South Texas Project Electric Generating Station 4000 Avenue F – Suite A Bay City, Texas 77414

February 10, 2010
U7-C-STP-NRC-100036

South Texas Project
Units 3 and 4
Docket Nos. 52-012 and 52-013
Response to Request for Additional Information

Attached are the responses to the NRC staff questions included in Request for Additional Information (RAI) letter numbers 299 and 302 related to Combined License Application (COLA) Part 2, Tier 2, Sections 3.7.1, 3.7.2 and 3.8.4.

Figure 3H.6-15a: SSI Model (structure only)

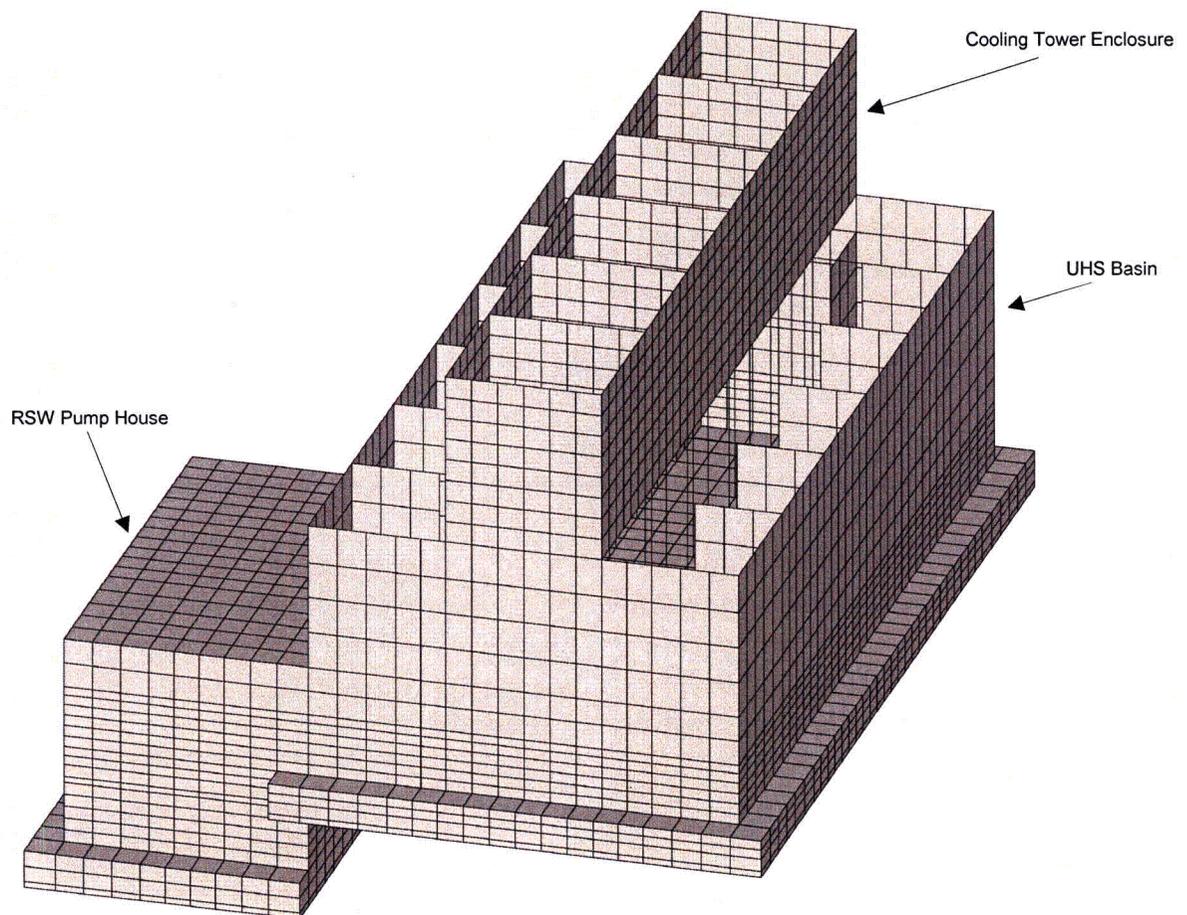
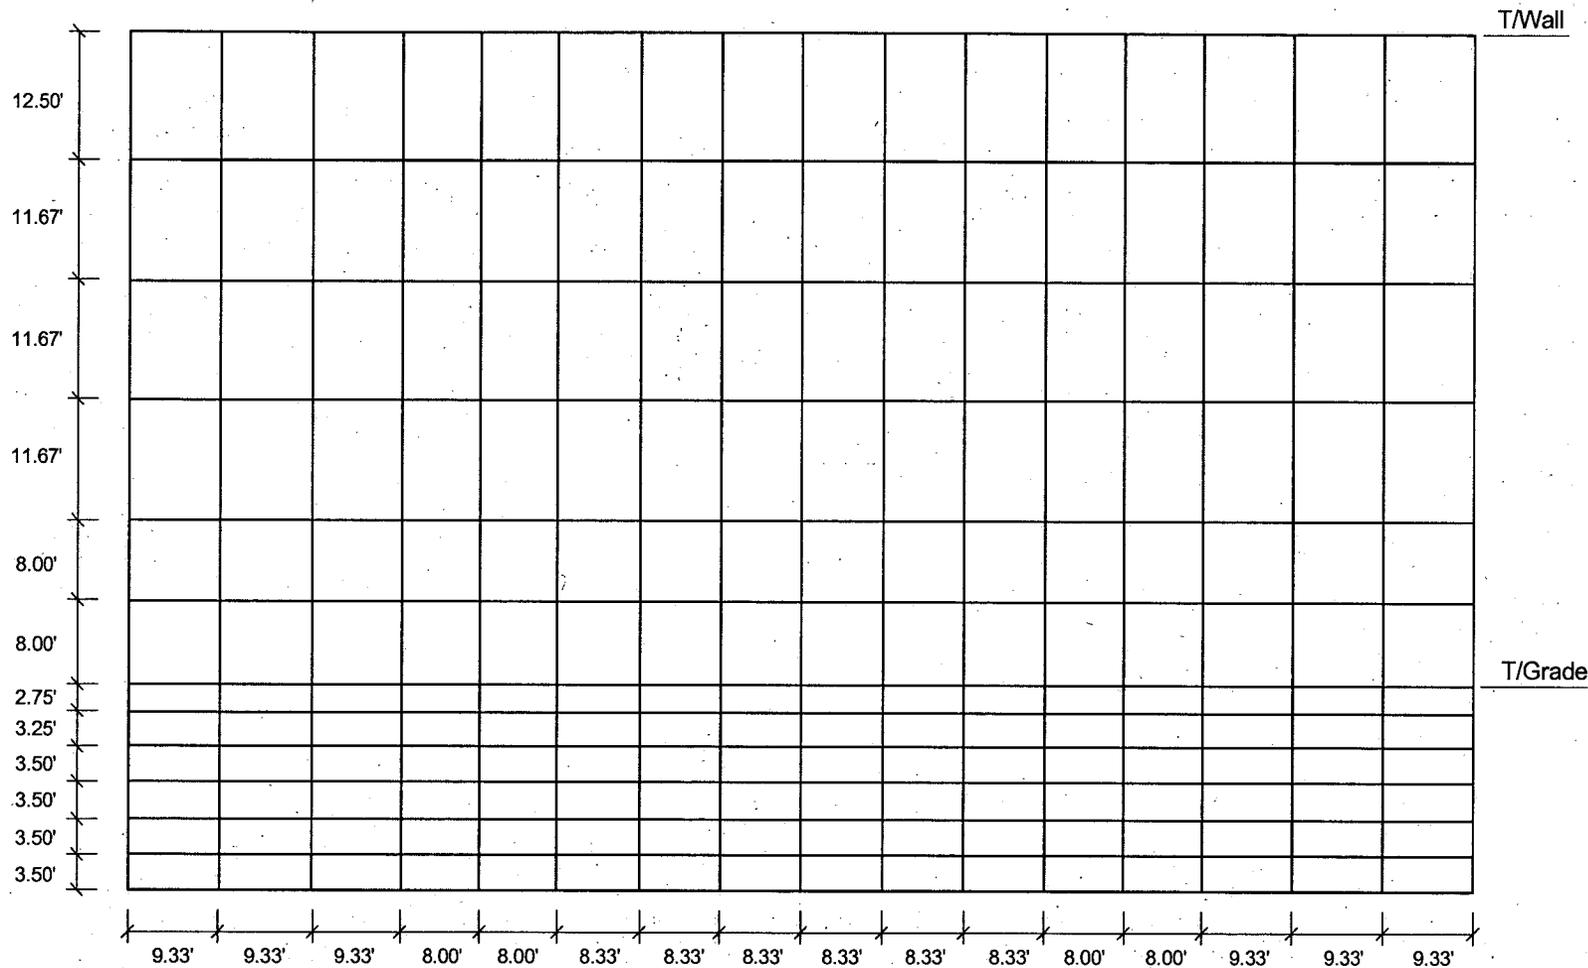
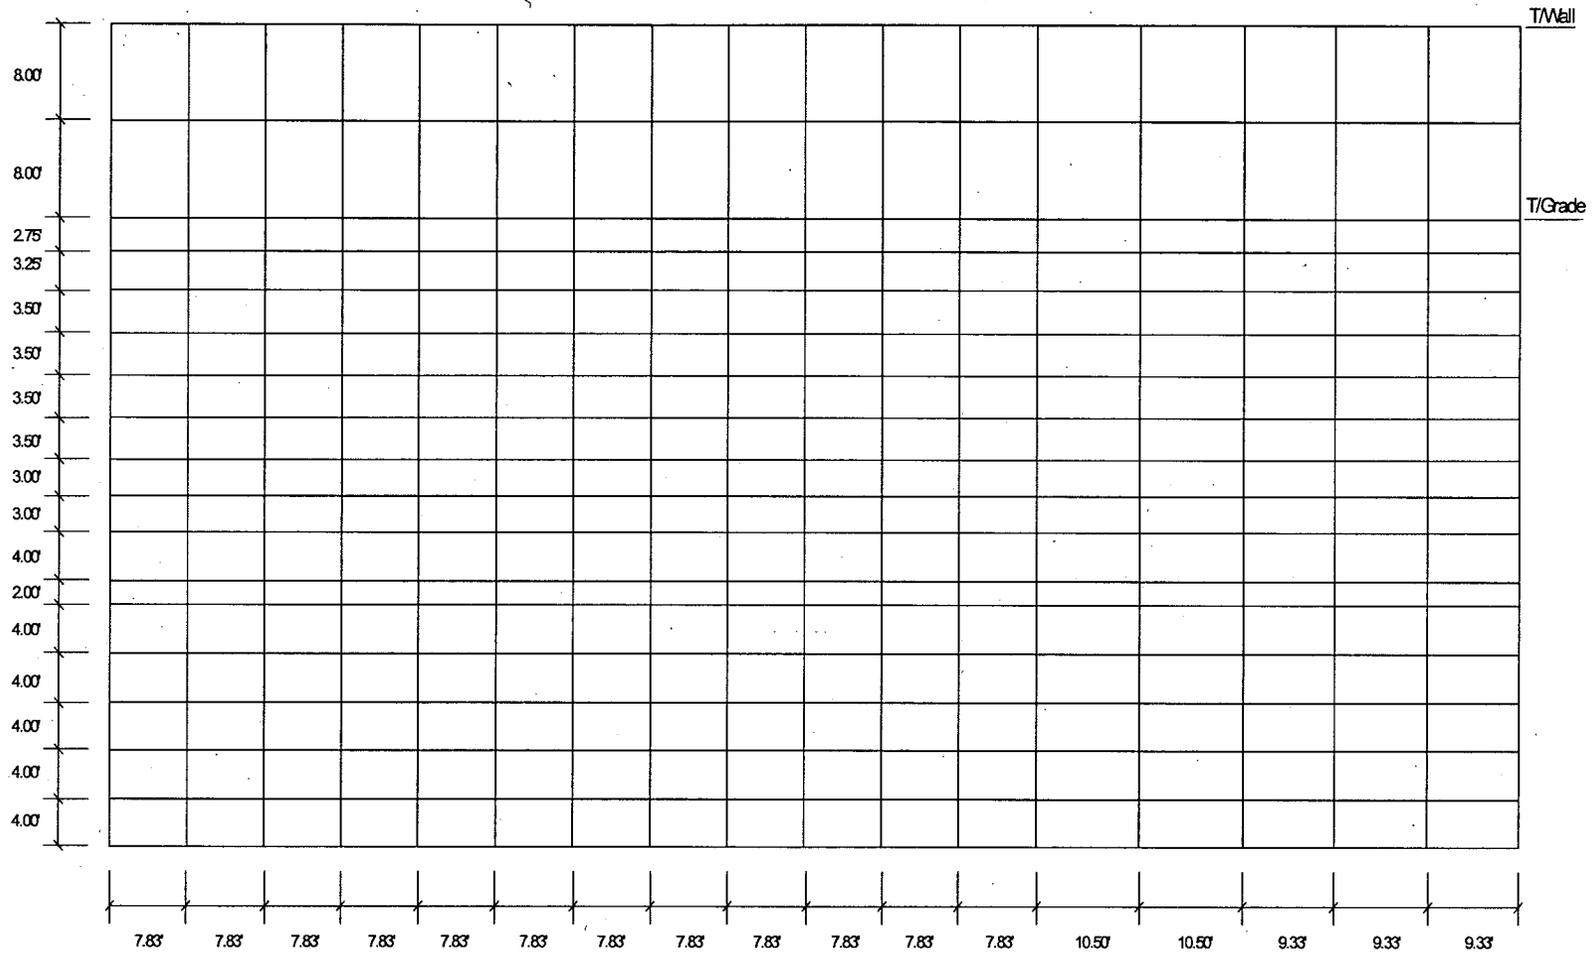
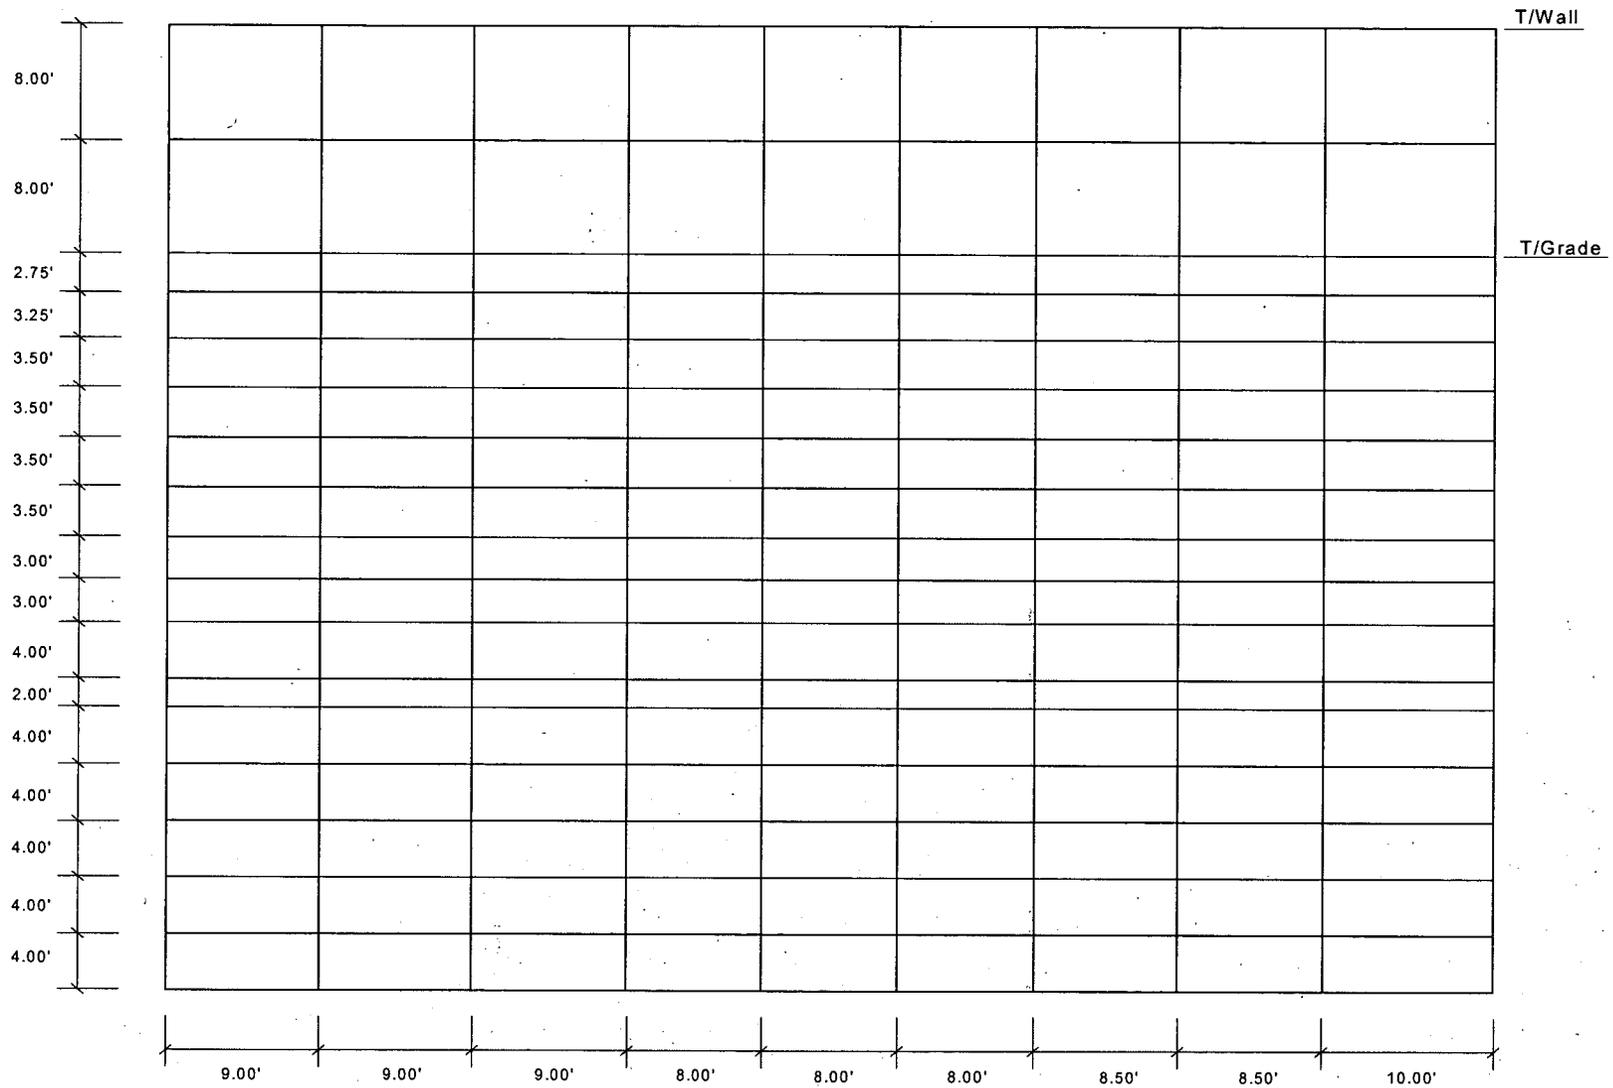
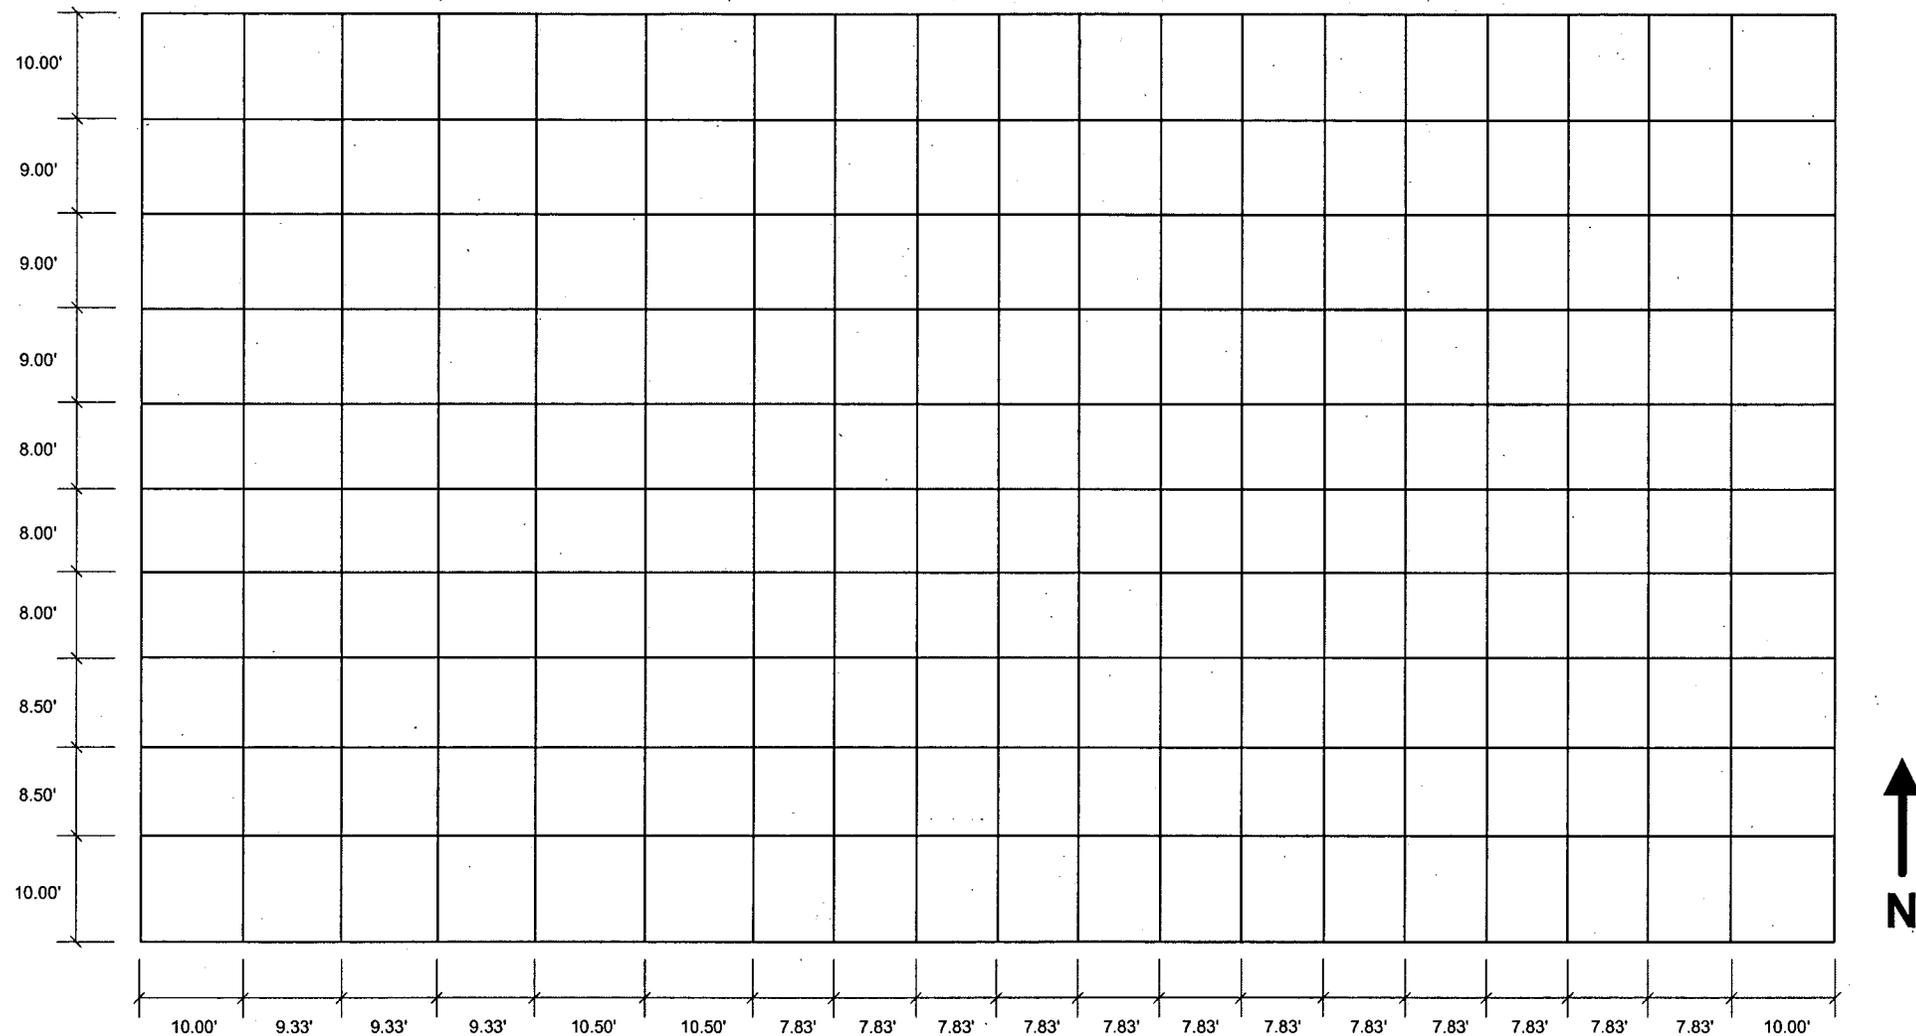
1. In the response to Item 2 of RAI 03.07.01-4, the finite element model of the UHS basin and RSW Pump House was not provided in Figure 3H.6-40 (this figure was supposed to be part of the response to RAI 03.07.01-13). The applicant is requested to ensure this information be part of Figure 3H.6-40, including a plot showing the basement slab and soil-retaining wall mesh configuration and grid sizes. The response to Item 2 of RAI 03.07.01-4 also states that, *“The model mesh size is detailed enough to model the principal features of the structure and transmit a frequency of at least 33 Hz.”* The applicant is requested to a) provide the criteria and quantitative basis to show that the element sizes are sufficiently small to transmit frequencies of up to 33 Hz for the three soil cases; and b) provide a justification that the aspect ratio of the elements is sufficiently small as not to affect the solution accuracy.

Figures 3H.6-15a through 3H.6-15g on the following pages provide the structure model used in the SSI analysis along with the additional requested information regarding mesh configuration and grid size of the basemat and the exterior walls.

The STP Units 3 and 4 COLA Part 2, Tier 2 will be revised to include the following Figures 3H.6-15a thru 3H.6-15g.

Figure 3H.6-137: Formulations Used for Calculation of Factors of Safety Against Sliding and Overturning

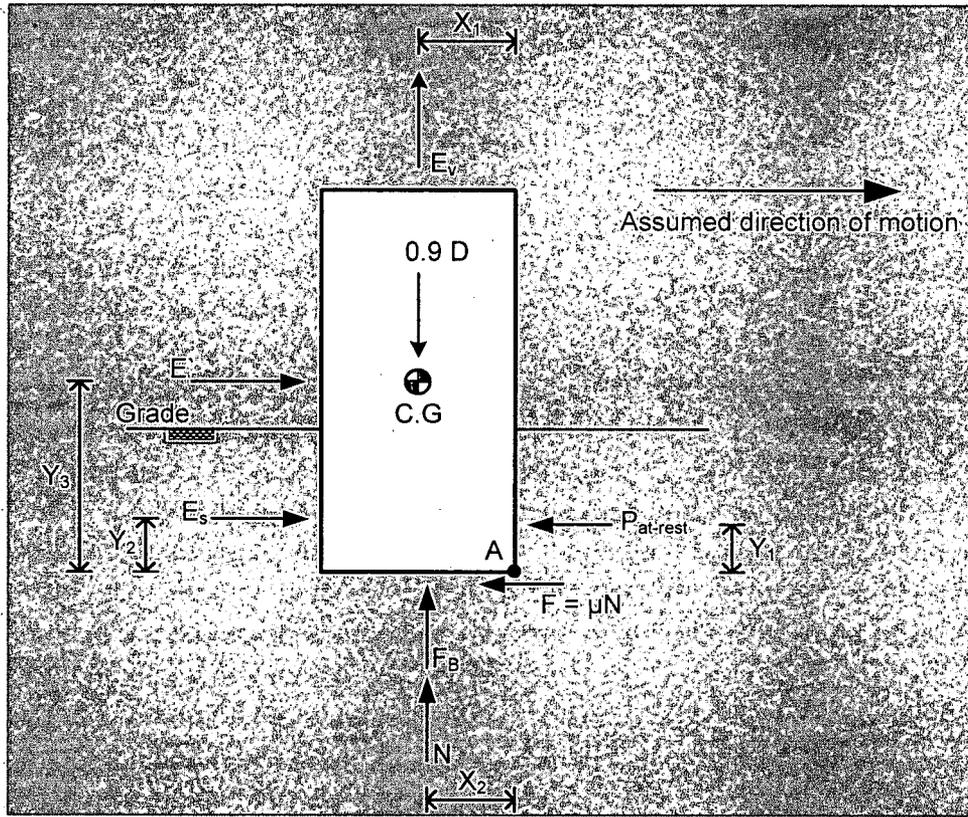
4. In the seventh and last bullet of the response to RAI 03.07.02-10, Figure 1 attached to this response shows the driving force "Es" as static and dynamic soil pressure but does not clarify the nature of the static soil pressure. The applicant is requested to clarify the nature of the driving static soil pressure in Figure 1. Also, please clarify how total at-rest soil pressure is calculated including algebraic expression. This figure with the above clarification should be included in the FSAR.

As requested, Figure 1 of the response to RAI 03.07.02-10 will be included in COLA Part 2, Tier 2 as new Figure 3H.6-137; see attached COLA mark-up.
